UNITED STATES PATENT AND TRADEMARK OFFICE

Office Action Summary	Application No. 09/813,372	Applicant(s) MURAO ET AL.	
	Examiner David C. Reese	Art Unit 3677

DETAILED ACTION

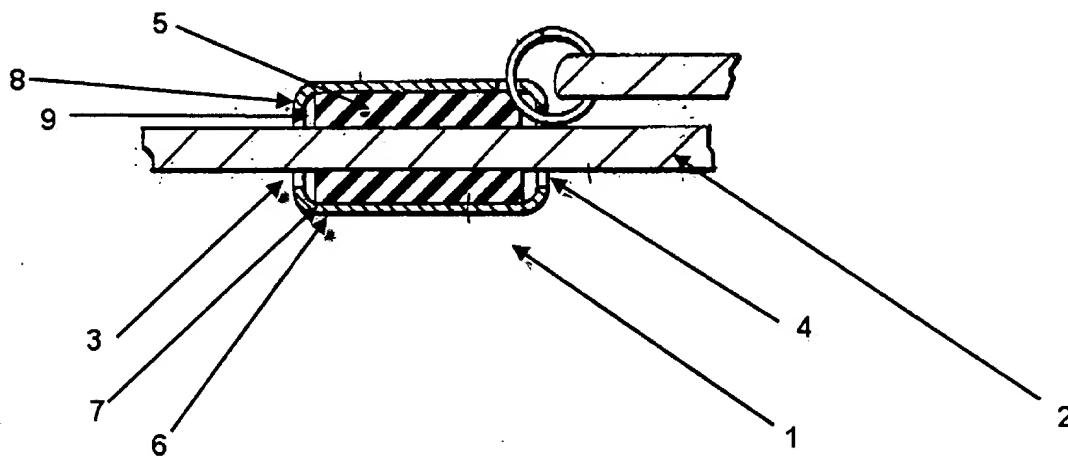
[5] Claims 15-18 are rejected under 35 U.S.C. 102(b) as clearly anticipated by Borofsky et al., US-4,321,804, because the invention was patented or described in a printed publication in this or a foreign country, or in public use or on sale in this country more than one (1) year prior to the application for patent in the United States.

The shape and appearance of Borofsky et al. is identical in all material respects to that of the claimed design, *Hupp v. Siroflex of America Inc.*, 122 F.3d 1456, 43 USPQ2d 1887 (Fed. Cir. 1997).

As for Claim 15, Borofsky et al. discloses of a retainer (see figure below) (1) for adjusting a length of an ornament chain (2), in which the ornament chain (2) is slidably insertable in said retainer (1), and can be locked at a desired pull-out position (see col. 2, lines 23-35, as well as part (e) of claim 1), said retainer (1) comprising:

a hollow casing (6) including an ingress port (3) and an egress port (4) separated from one another and adapted to allow the ornament chain (2) to pass therethrough; and

a resilient member (5) including a resilient tube having end parts and a through hole communicable with the ingress port (3) of said casing (6) for receiving the ornament chain (2) therethrough, the end parts of said resilient member (5) abut against an inner wall of said casing proximate the respective ports (at 7), an inner wall (8) of said casing (6) being separated from said tube (5) so as to define a gap (9) therebetween.

As for claim 16, Borofsky et al. discloses a retainer (see figure above) (1) for adjusting a length of an ornament chain (2), in which the ornament chain (2) is slidably insertable in said retainer (1) and can be locked at a desired pull-out position (see col. 2, lines 23-35, as well as part (e) of claim 1), said retainer (1) comprising:

Re: Claim 17, wherein end parts of said casing (1) are formed so that the diameter thereof decreases toward the respective ports (3, 4), the end parts of said resilient member (5) abut against an inner wall (at 7) of said casing (1) proximate the respective ports (3,4).

Re: Claim 18, wherein the end parts of said casing (1) are formed so that the diameter thereof decreases toward the respective ports (3,4), said resilient member (5) abuts against an inner wall (at 7) of said casing (1) proximate the respective ports (3,4).
